CITY OF DELRAY BEACH
100 N.W. 1ST AVENUE, DELRAY BEACH, FL 33444

Solicitation Addendum

Addendum No.: 3
Solicitation No.: 2017-065-2
Project No.: 17-008
Solicitation Title: Phase 1 of Seacrest Beautification
Addendum Date: August 31, 2017

NE 2ND AVENUE / SEACREST

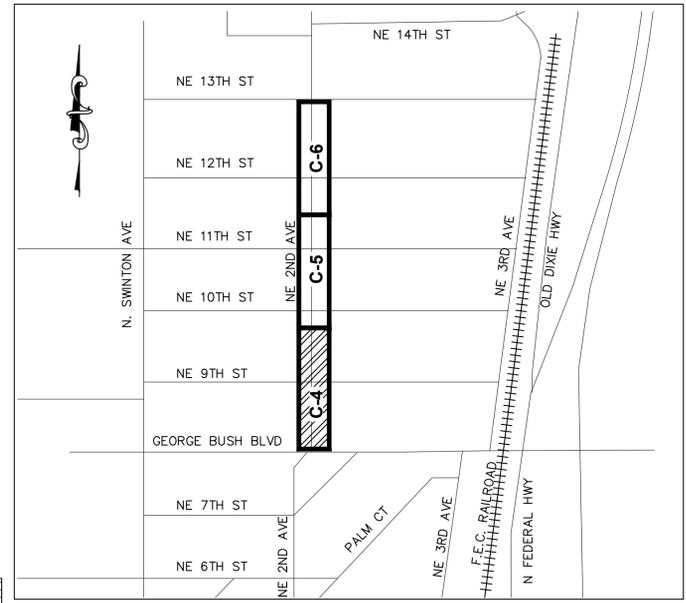
Q18. Sheet C-4: The limits of Construction shown at George Bush Blvd do not include the areas shown on C-16 which call for new loops and pedestrian signals south of the BEGIN PROJECT STA 36+18.66. Please clarify. Also, it appears the loops south of George Bush Blvd (Labeled L-6 on Sheet C-16) were installed in Phase 0. Please confirm that these are not required to be reinstalled during this Project.

R18. Exhibit A, Drawings, Cover Sheet, Sheet C-4, and Sheet C-13 are revised per this Addendum No. 3.

SHEET: C-16

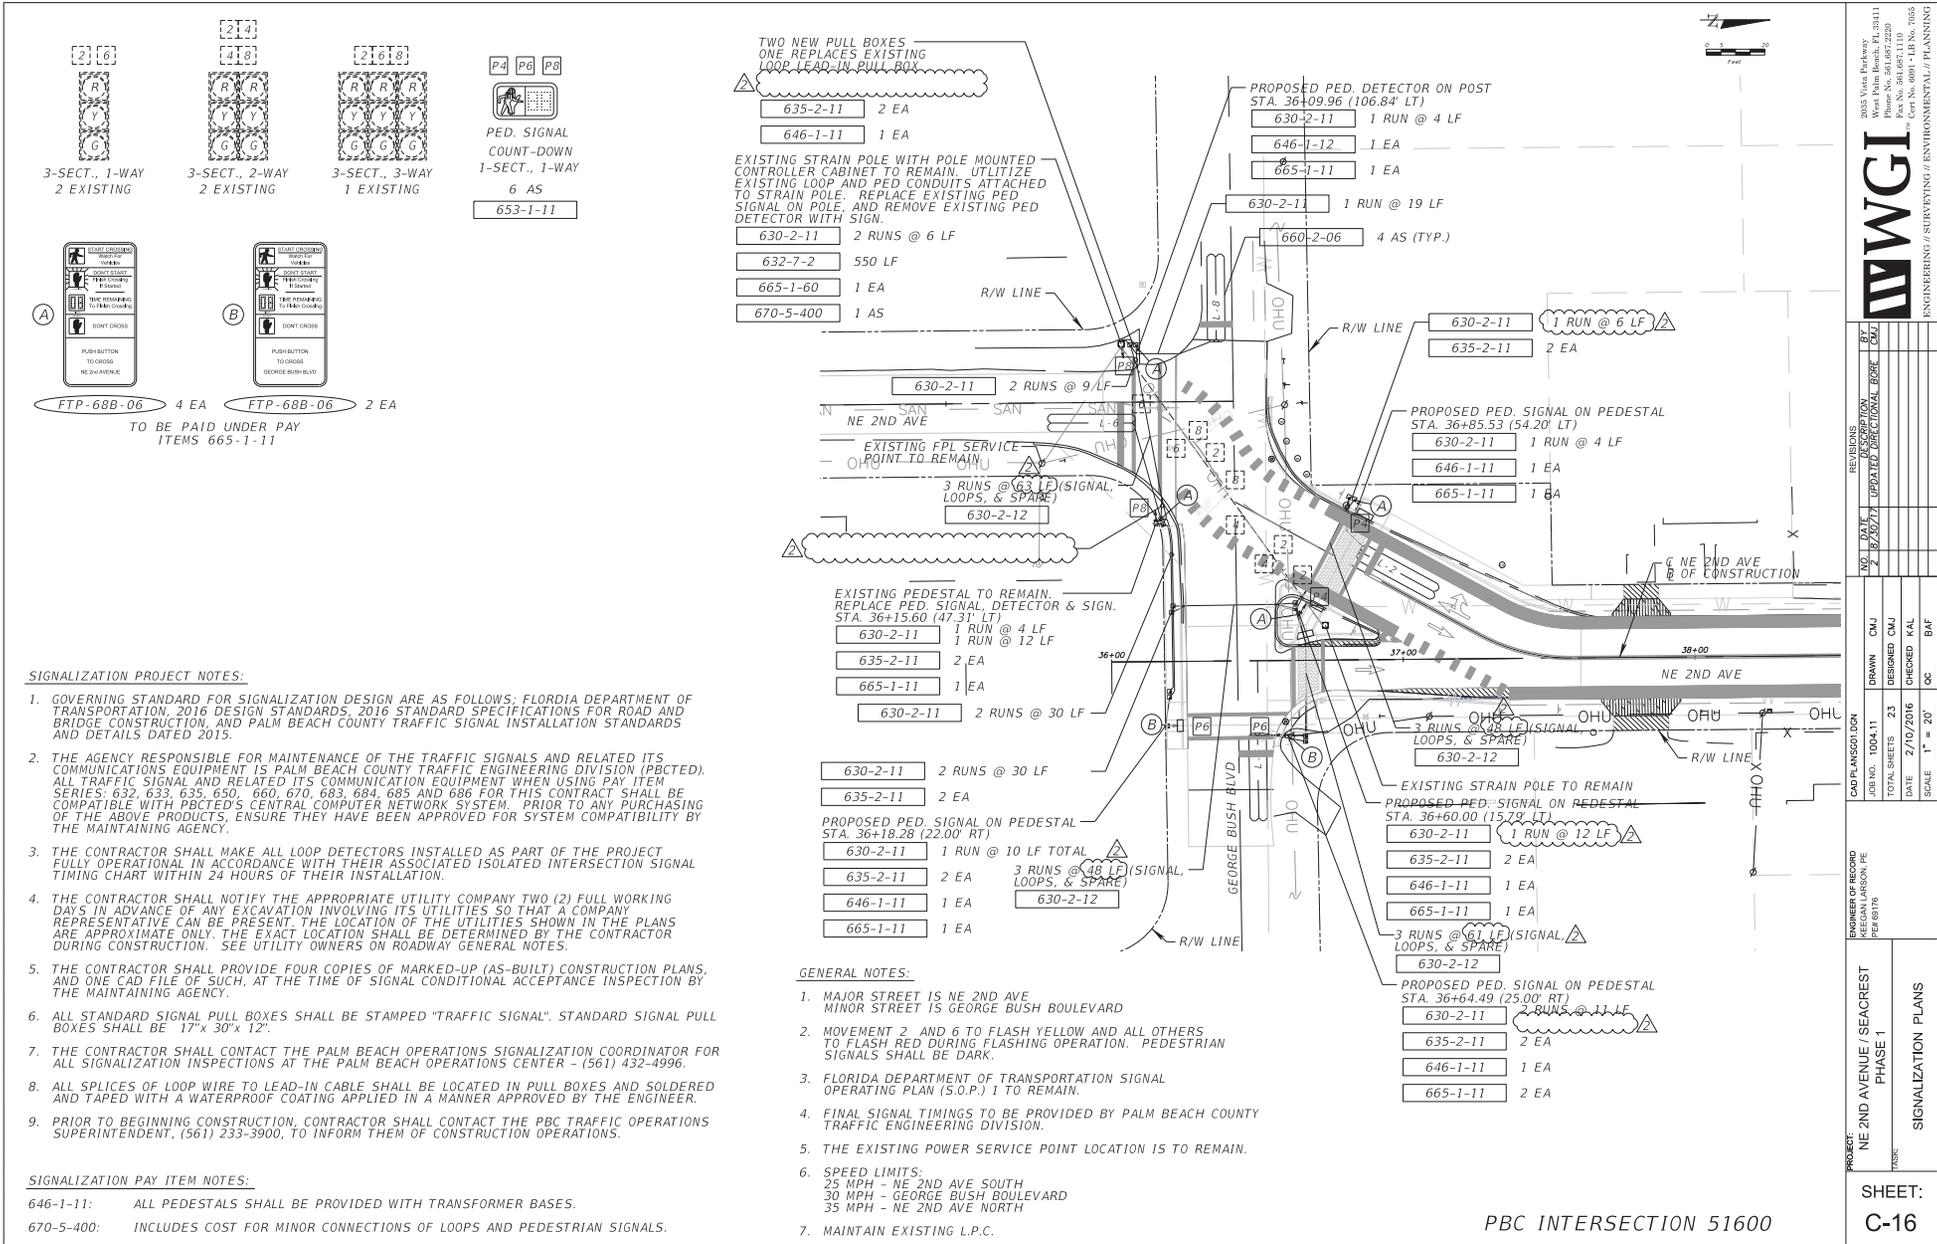
Q16. Sheet C-16 shows new conduit crossing George Bush Blvd and NE 2nd Avenue. These are listed as 630-2-12 Pay Items. This is for a directional bore installation. The directional bore LF listed on the item only accounts for the area directly under the asphalt. In reality, the LF of boring that needs to be installed is much greater as it is impossible to start and end the bores at PRECISELY the edge of pavement on both sides of the road. The notes list 3 Runs of the following: 45, 30, 31, and 17 LF for a total of 3 runs of 123 LF. We estimate approximately 3 runs of +-200 LF. We recommend clarifying these notes as the pay item description for 630-2-12 states: “**Measurement is for the straight line HORIZONTAL DISTANCE of the trench or bore, from pull box to pull box**” and the current quantity on the plan is not reflective of Pull box to pull box, and may leave you open to claims.

There may not be enough room for performing a directional bore without utilizing portions of the adjacent private properties as either starting or ending points. Has the City procured Construction Easements with the adjacent properties on all corners?

R16. Exhibit A, Drawings, Sheet C-16 is revised per this Addendum No. 3.

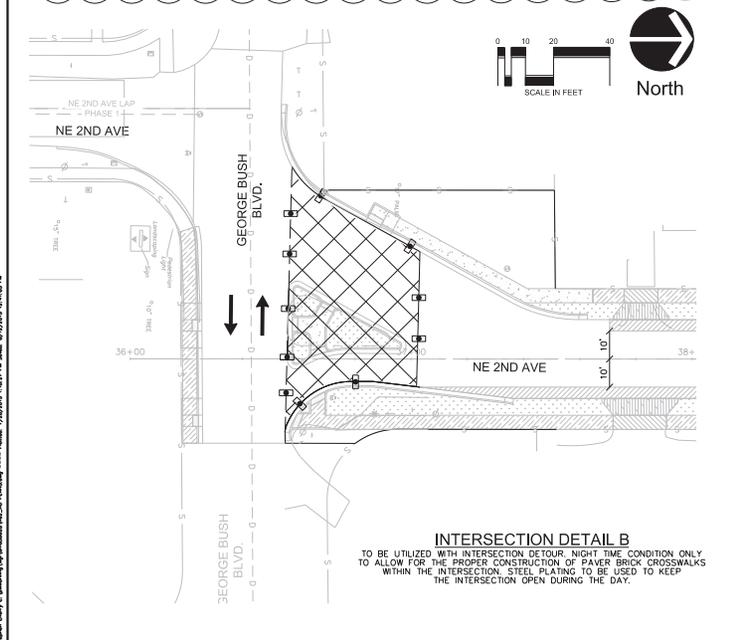
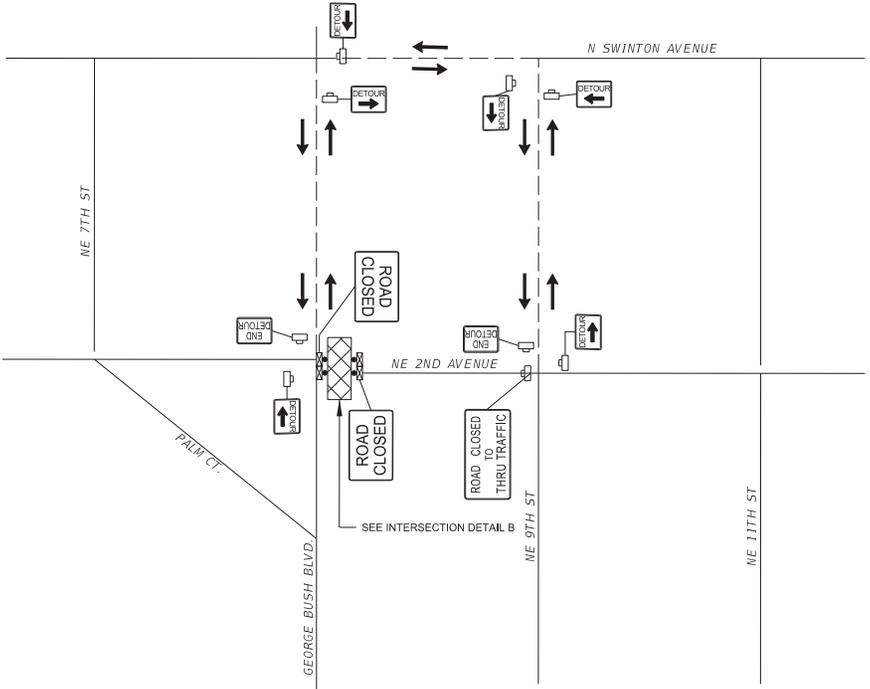
- Q5. Is the contractor responsible for the cost of hiring a designer to provide MOT plans for scopes of work which cannot be accomplished with the provided plans and the Design Standard 600, 603 and 660 referenced, or will the City utilize the EoR to provide these designs at the request and coordination of the Contractor? One Example of work not covered by the design standards or provided plans: Sidewalk and Curb on George Bush Blvd Eastbound/Westbound. FDOT states that work within 2 feet of the travel lane shall require a lane closure/Shift/Flagging. No MOT plan provided and no design or standard provided for flagging through an intersection one-lane in both directions.

- R5. Exhibit A, Drawings, Sheet C-23 is revised per this Addendum No. 3 to include the work zone and MOT scheme to construct the sidewalk and curb along George Bush Blvd. A lane closure is not anticipated as there is approximately 31' of existing pavement in this area which can accommodate a minor traffic shift.**
